SUMMARY OF CHANGES FROM
APPROVED PLANNING REF 233180

EXTENSIONS, ALTERATIONS AND NEW ANCILLARY BUILDING

L'ORTOLAN PROPOSED ELEVATIONS

JOB No	DRAWING NUMBER
1149	P16 revC

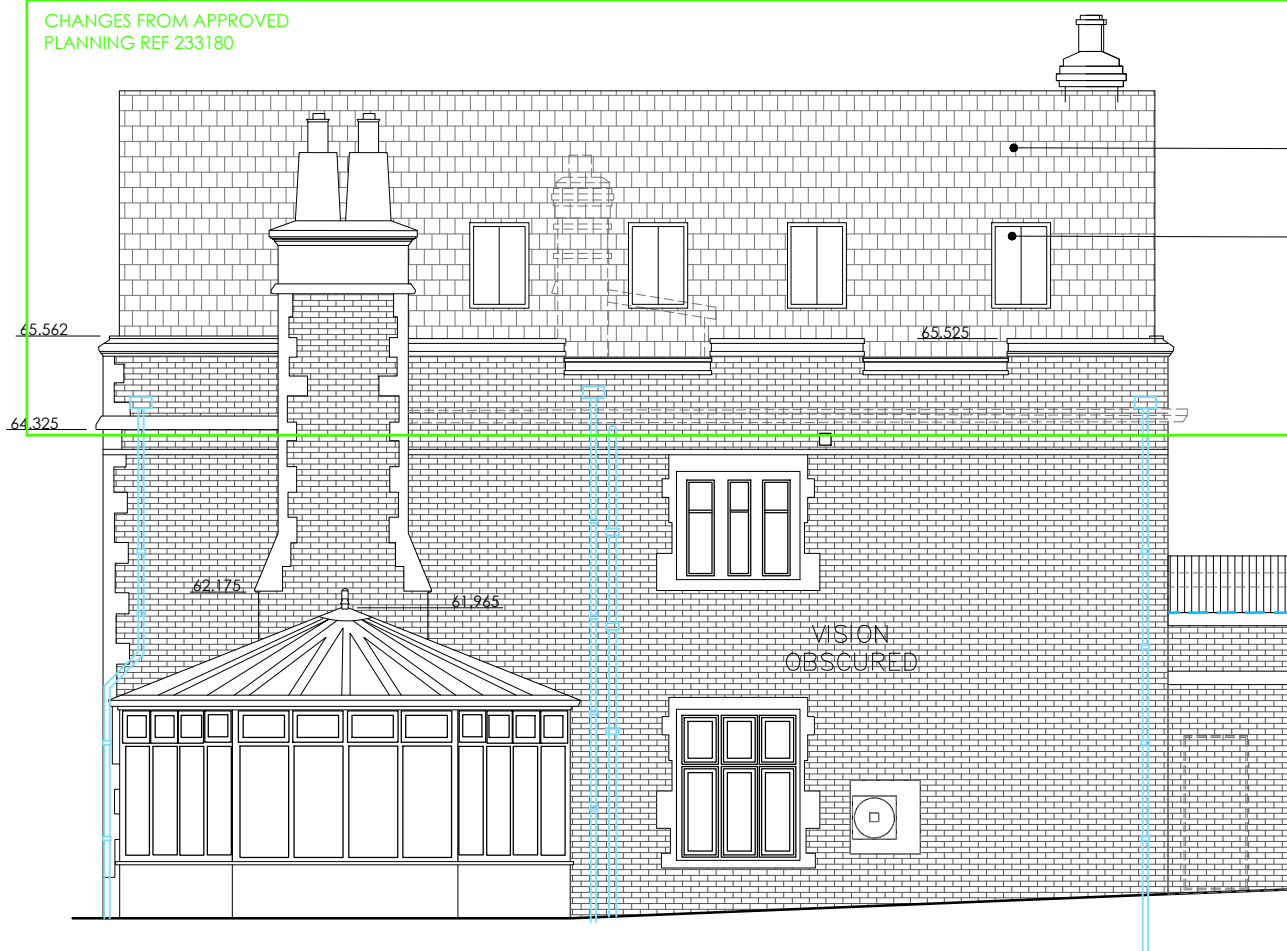
CHANGES FROM APPROVED
PLANNING REF 233180

— slate roof o match annex building

- conservation rooflight

- black wrought iron balustrade

- new planters to collect water from terrace
- new stone bands to match existing.

SE ELEVATION

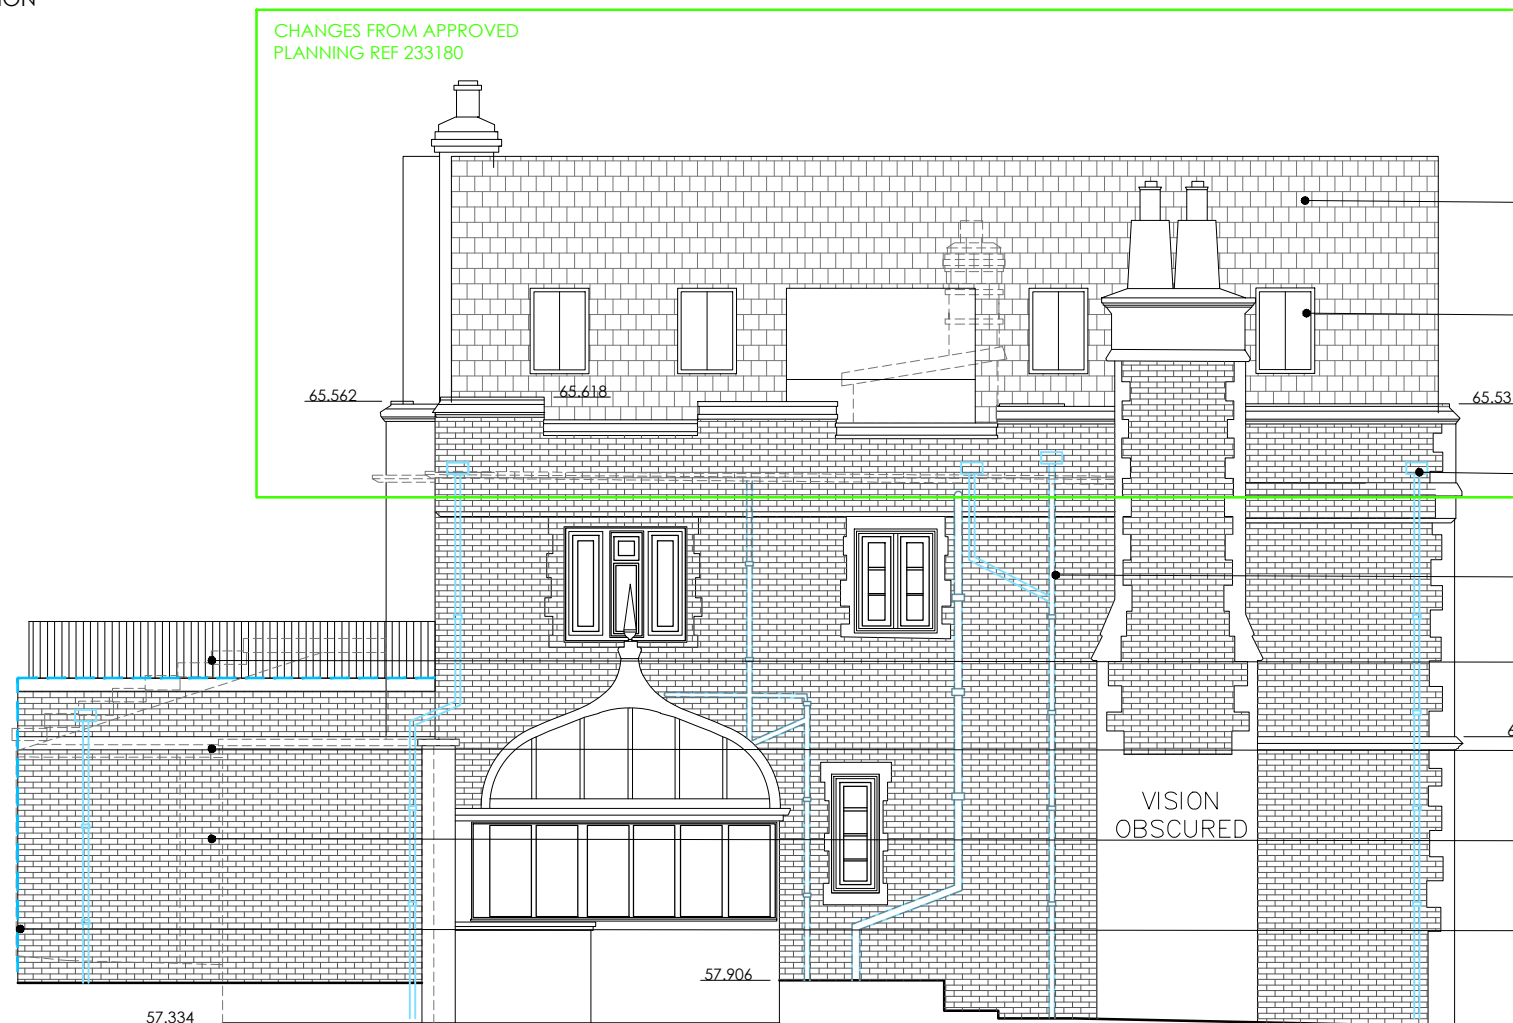
High water resistant solid bricks to match existing to create hit and miss brick wall

allow water from the coping to run towards the terrace

terrace drain channel
to connect to hopper
and collect water
from central bay

CHANGES FROM APPROVED
PLANNING REF 233180

slate roof to match annex building

- conservation rooflights

- new hoppers to collect water from terraces

replace gutters and downpipes with a system to match. were possible new downpipes to be placed in the same position of the existing removed downpipes.

- black wrought iron balustrade

new stone bands to match existing.

NW ELEVATION

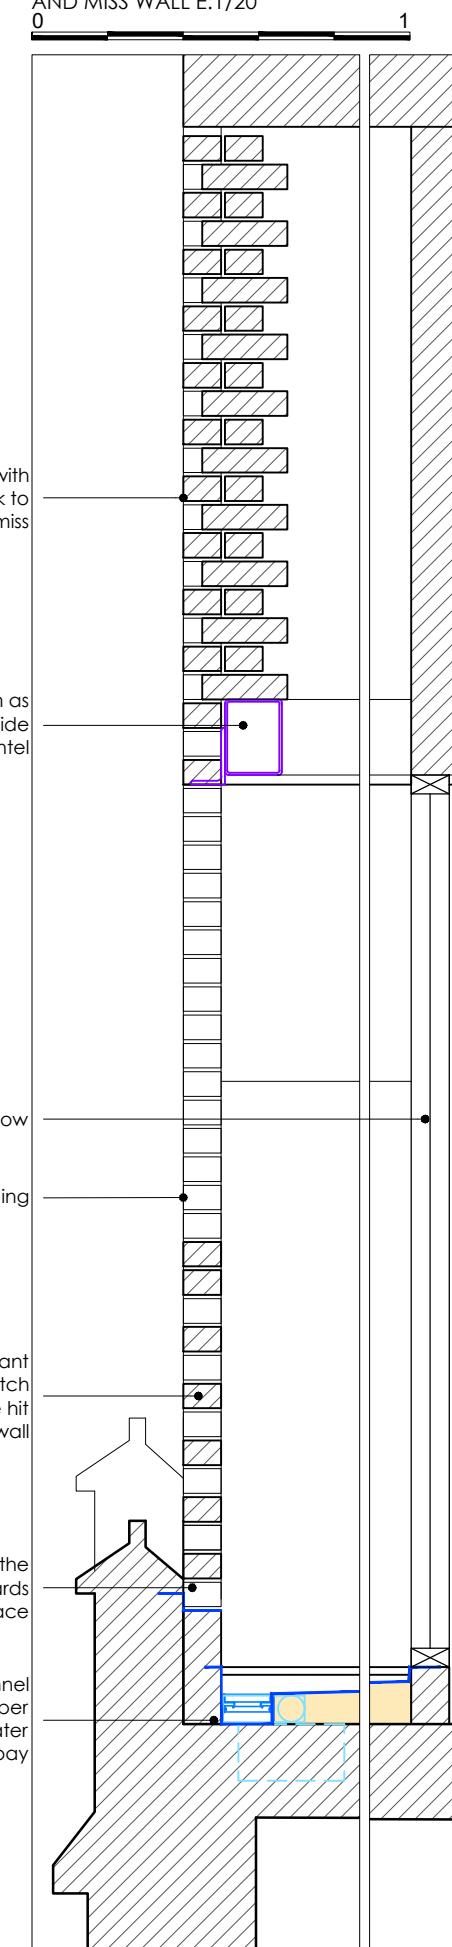
new brickwork to match existing building.

extension as approved
— application ref num 233180 and
233181 shown in dotted blue line
